BZAP Staff Report

FOR May 22, 2025 6:00PM

App No: BZAP 25-17
 Address: 51 S Dawson
 Applicant: Gary Alexander

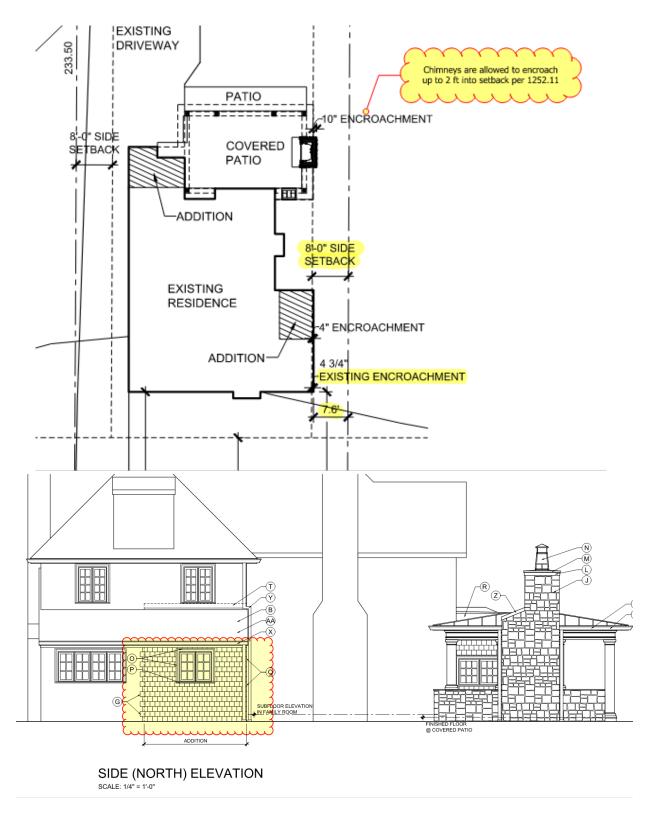
REQUEST: The applicant is seeking a Certificate of Appropriateness and 4" area variance to encroach into the side yard setback in order to expand the current study.

- R-6 Zoning = 8 ft side yard setbacks
- The house has an existing encroachment of 4" on the north side.
- Applicant is building an addition and would like to keep the north wall of the addition in line with the existing house
- Per 1252.11, chimneys are allowed to project into the side yard no more than 2 ft.

- Thus the only variance needed for this application is the 4" side yard encroachment in order to align the wall of the new addition with the existing house
- Application was put on consent agenda and passed unanimously at May ARB Mtg
- Staff sees no issue with this variance.

App No: **BZAP 25-21** Address: 126 S Parkview Applicant: **Bailey Moore** Owner: Front Yard LLC

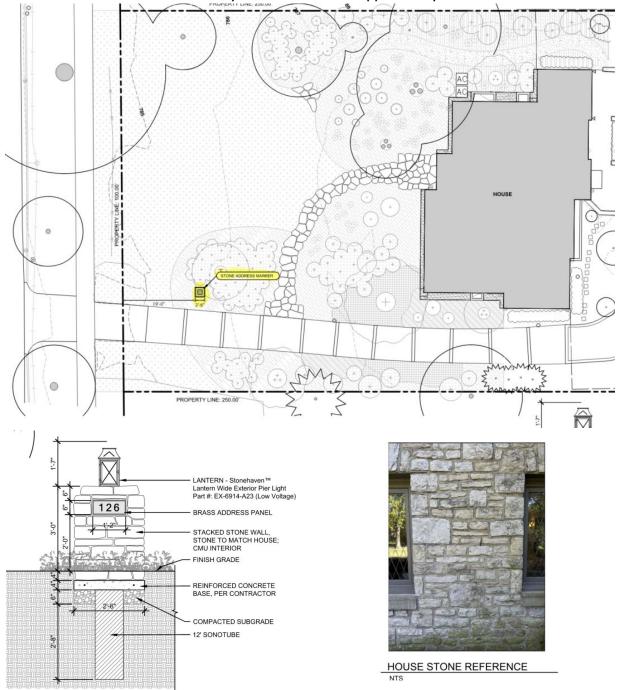
Request: Applicant is seeking approval for an area variance in order to install a

front yard address column.

1230.82 -- "Structure" means anything constructed or erected more than 6" above grade, the use of which requires location on the ground or attachment to something having a fixed location on the ground. Among other things, structure includes buildings, walls, fences, decks, and signs.

- 1252.15.g.1 states that accessory uses and structures shall be permitted only in the rear yard...
- Staff is working on design guidelines for address columns as well as an ordinance that may allow these to be approved by the staff.

6) App No: BZAP 25-22 Address: 2529 E Broad Applicant: Melissa Rothier

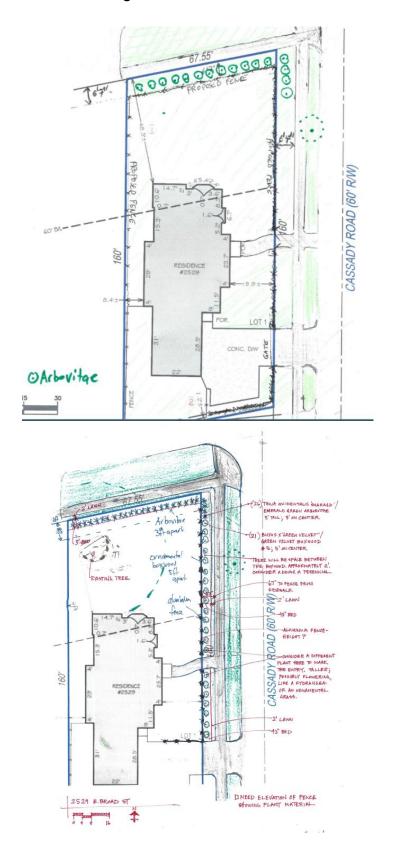
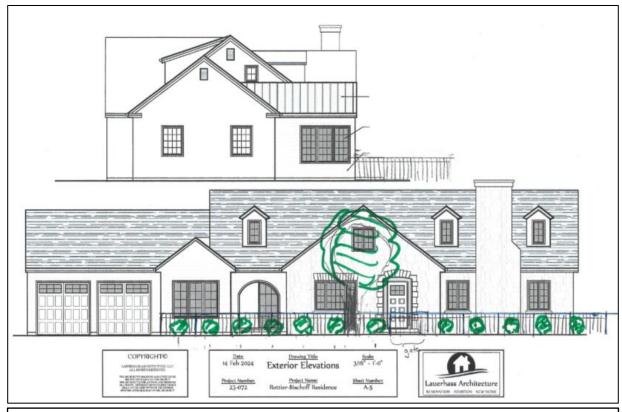
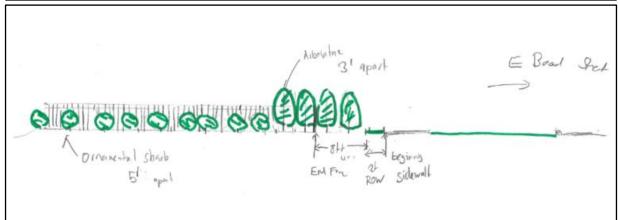
Request: The applicant is seeking a special permit to install a 42" tall front yard fence.

- This property and fence application came before the board in August of 2023 for the same fence review.
- Per I226.II If construction has not begun or the variance established within one year of the final approval of an area (non-use) variance granted by the Board of Zoning and Planning, the variance shall expire. The Zoning Officer shall have the discretion and authority to extend the variance approval for an additional one-year period if an application for extension is received before the authorization expires. If no construction has begun at the end of this extension, the variance shall become null and void, and a new variance shall be required for any development requiring a variance on that property.

- The Board granted approval with the conditions that the fence be set back
 8ft -10ft from the property line along Broad St. to work around a large existing tree

- Also, the Board conditioned approval upon a landscape plan be reviewed and approved by the City's Landscape Consultant.
- Staff requests if approved that the same conditions be added.

App No: BZAP 25-8
 Address: 49 S Parkview
 Applicant: Darren Ramler
 Owner: Anna Kamp

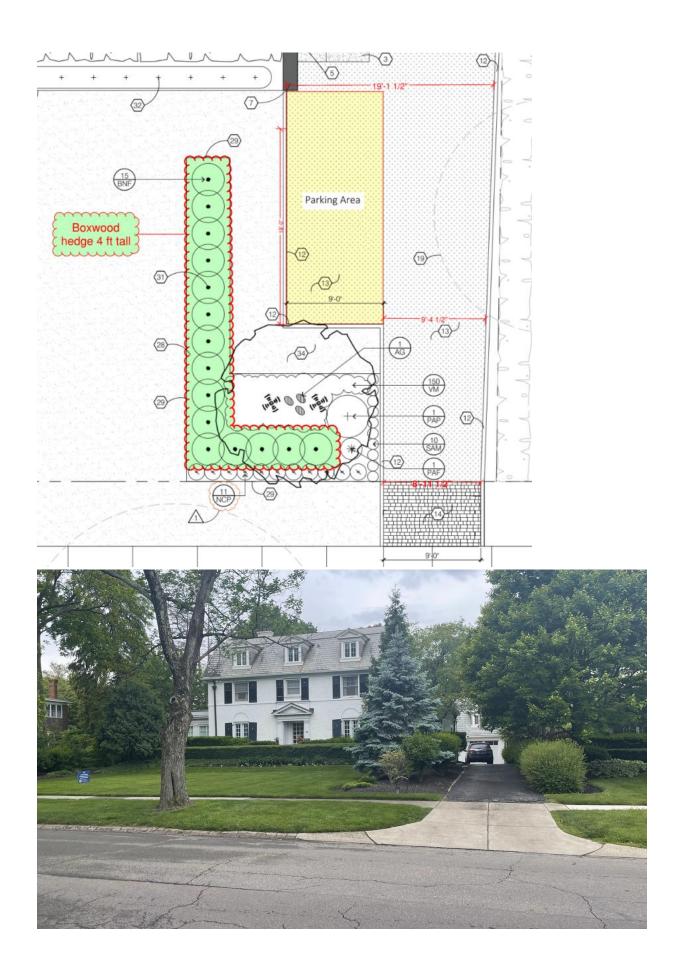
Request: The applicant is seeking a variance to Bexley Code Section 1262.02(b)

& 1262.01 (e) to allow a front yard parking space

- 1264.04 (b) No spaces, aisles, or any portion of a driveway that does not access a rear yard parking space or garage shall be located in the front yard in an R-1, R-2, R-3, R-6, R-12 or OS District.

- 1262.01 (e) An access drive shall not exceed the normal width necessary to allow for a convenient movement of traffic and shall not be used for temporary or permanent parking. In the R-I, R-2, R-3, R-6, and R-I2 Districts, access drives shall not be less than 8 feet and no larger than 12.5 feet in width and shall not occupy more than 25% of the front yard.

- Applicant is renovating the exterior front landscaping and driveway to the property.
- They would like to widen their driveway to accommodate a front yard parking spot so that other cars can get to the rear yard parking.

- Applicant has stated that the parking space will be screened.
- The code is specific upon not allowing front or side yard parking and because of this staff does not support this variance.

- Should the Board grant the variance, Staff recommends having the applicant fill out a Landscape application for review and approval by the Tree & Public Garden Commission.
